Report Type: DA Access Report
Reference Number: 18114
Client: Designcorp Architects
Site Address: 1 Edna Street, Kingwood

ACCESS REPORT

This Access Compliance Report is to accompany a Development Application for the development proposed at 1 Edna Street, Kingwood

Floor plans shown above

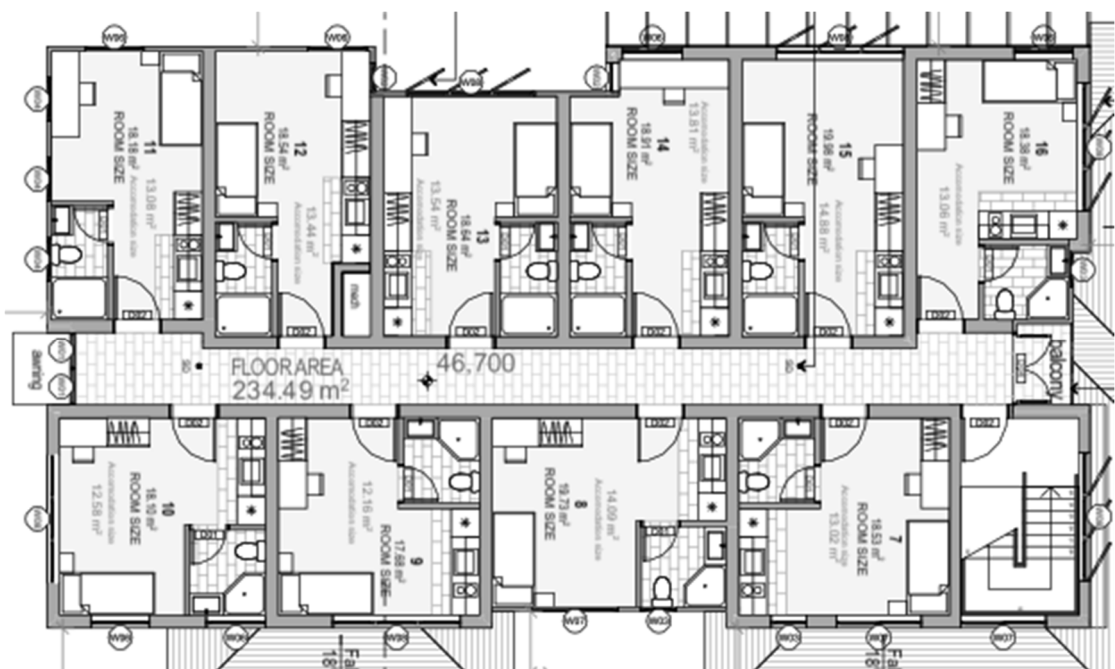
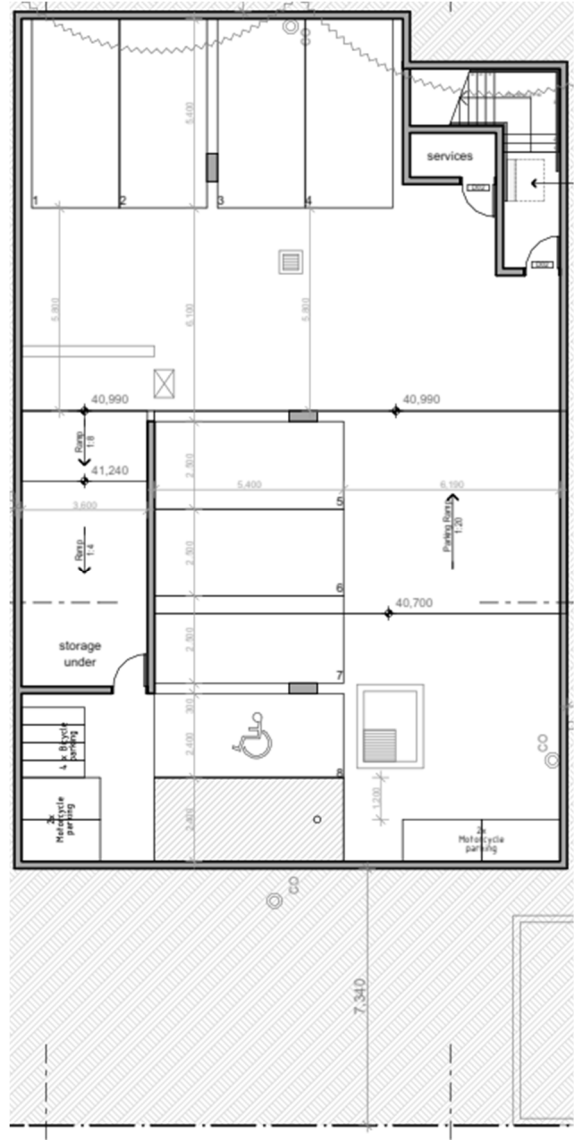
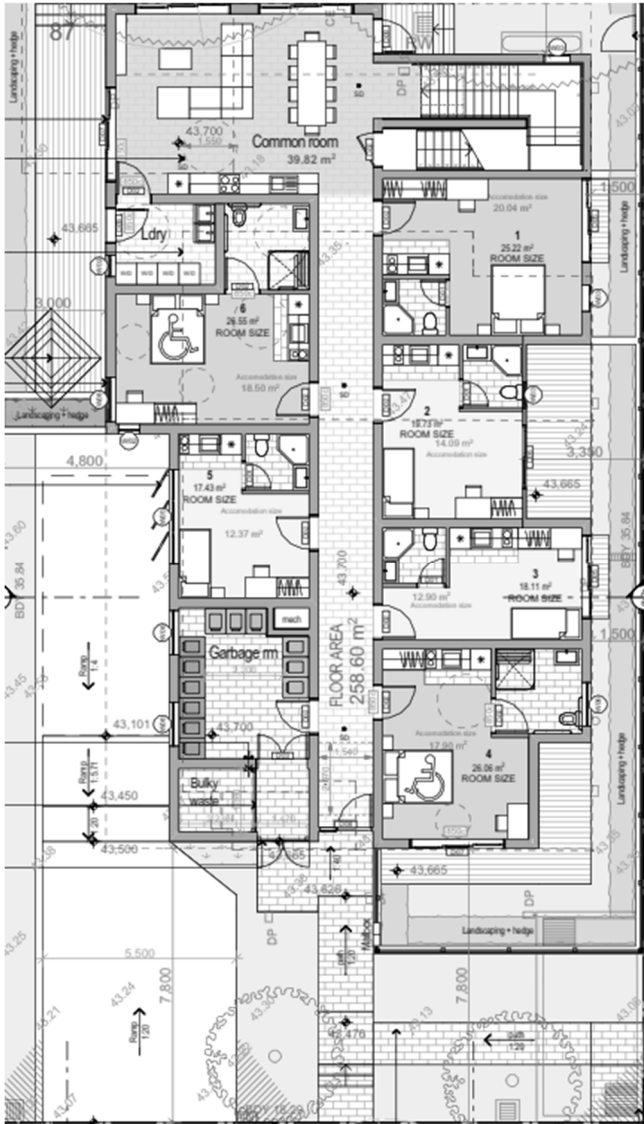
The assessment of the proposed development has been undertaken to the extent necessary to issue DA (Development application) consent under the Environmental Planning and Assessment Act. The proposal achieves the spatial requirements to provide access for people with a disability and it is assumed that assessment of the detailed requirements such as assessment of internal fit-out, details of stairs, ramps and other features will occur at CC (Construction Certificate) stage.

By compliance with the recommendation in this report, the development complies with the requirements of Access Code of Disability (Access to Premises-Building) Standards 2010 and the Disability Access relevant sections of Building Code of Australia 2016.

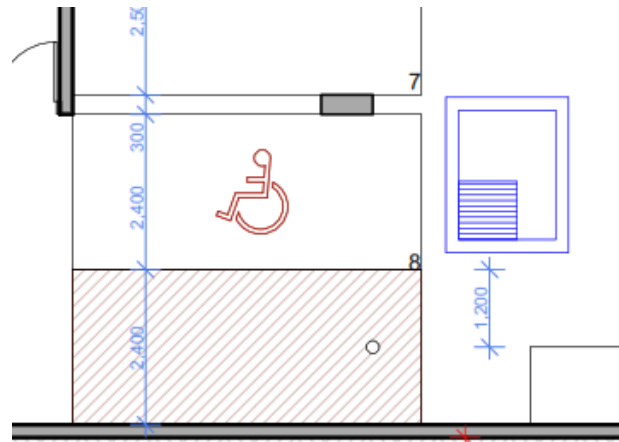
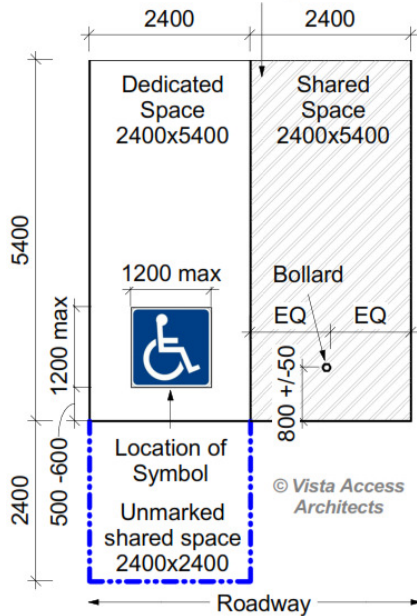
150-200 wide diagonal stripes with spaces
200-300 between stripes at 45+/- 10°

The Accessible parking, shared zones, bollard and linemarking to be as shown above.

The development has a requirement for 2 Accessible SOUs.
The nominated Accessible SOUs are Unit numbers, 4 and 6 as shown below

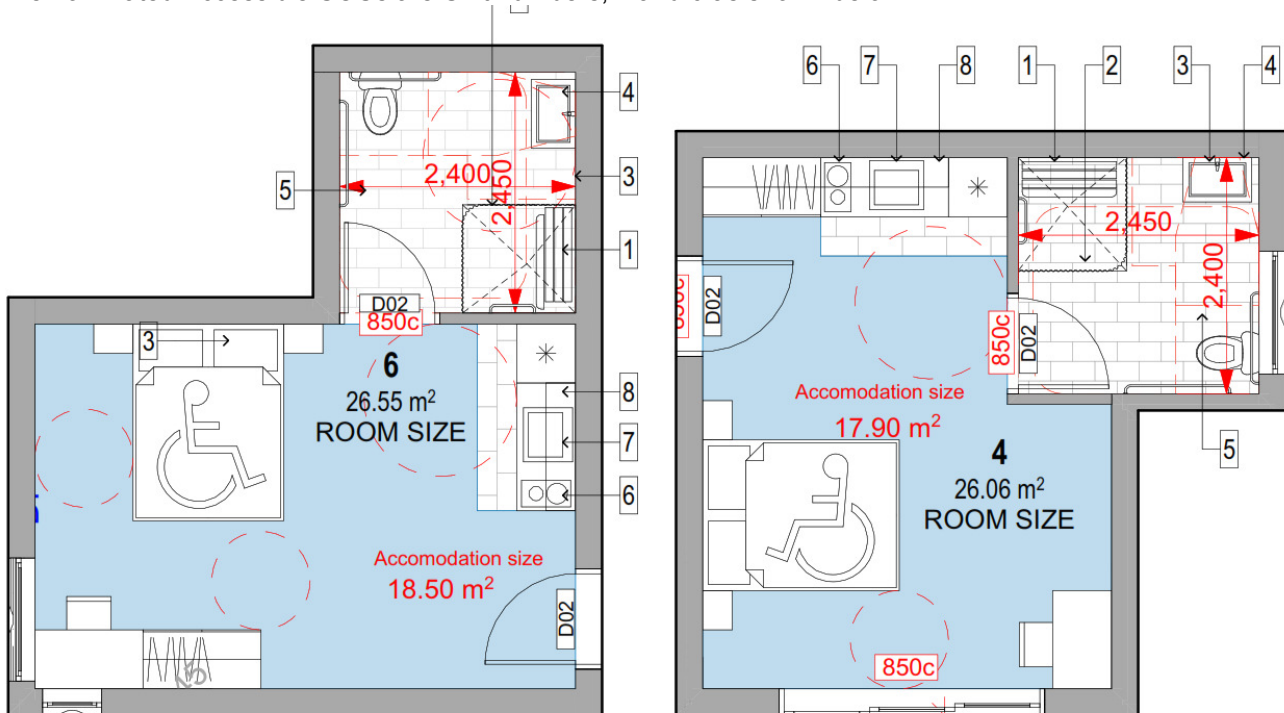
Requirements as per AS1428	R	C	Comments
1	Doorways			
	All doors including entry door to provide 850mm clear opening space with the necessary door circulation spaces and fixtures as specified under AS1428.1	☑	☑	Complies Details to be verified at the CC stage of works.
2	Bathroom			
	At least 1 Bathroom to accommodate, WC pan, Shower and handwash basin with the necessary fixtures and circulation spaces as specified under AS1428.1	☑	☑	Complies Details to be verified at the CC stage of works.
3	Laundry			
	Where internal laundry provided, provide for a space of 1550mm space in front of laundry appliances.	☑	☑	Complies Communal laundry has been provided which is designed to be accessible. Details to be verified at the CC stage of works.
4	Main bedroom / or space around a bed			
	At least 1 bedroom to have a queen bed with circulation space of 1540mm x 2070mm at the base or side of the bed and at least 1M on the other 2 sides. In the case of a boarding house a single bed may be used with the same circulation spaces.	☑	☑	Complies Circulation spaces are available around the queen bed. Details to be verified at the CC stage of works.

5	Living areas			
	Adequate circulation space is to be available after the placement of furniture. Circulation space of minimum 2250mm diameter is considered to be appropriate.	<input checked="" type="checkbox"/>	<input checked="" type="checkbox"/>	Complies Communal living area has been designed to be accessible. Details to be verified at the CC stage of works.
6	Kitchen / Kitchenette			
	Where internal kitchenette provided, 1550mm clear spaces is required in front of the benchtops. Provide long arm lever tap and 1 double GPO within 300mm of front bench. Consideration to be given to provision of an 850mm section without base cabinetry or removable cabinetry to allow for access to benchtop and a benchtop space of 800mm between the fridge and cooktop.	<input checked="" type="checkbox"/>	<input checked="" type="checkbox"/>	Capable of compliance. A space of 1550mm is provided in front of the kitchenette. Details to be verified at the CC stage of works.

7	Balconies and outdoor areas			
	Where access is available from the unit to the outdoor areas such as balconies and courtyards, an accessible threshold is required, with door tracks for sliding doors (if any) to be flush with the internal floor level and max height of external threshold ramp of 35mm height.	<input checked="" type="checkbox"/>	<input checked="" type="checkbox"/>	Capable of compliance. The sliding door to the communal open space from the communal room is required to have a flush threshold with a max drop of 35mm to outside when used in combination with a doorway threshold ramp. A 530mm latch side space will also be required. Details to be verified at the CC stage of works.
8	Flooring			
	All flooring is required to be step free. Construction tolerances, slip resistant and waterproofing to be as required under relevant Australian Standards.	<input checked="" type="checkbox"/>	<input checked="" type="checkbox"/>	Capable of compliance. Details to be verified at the CC stage of works.
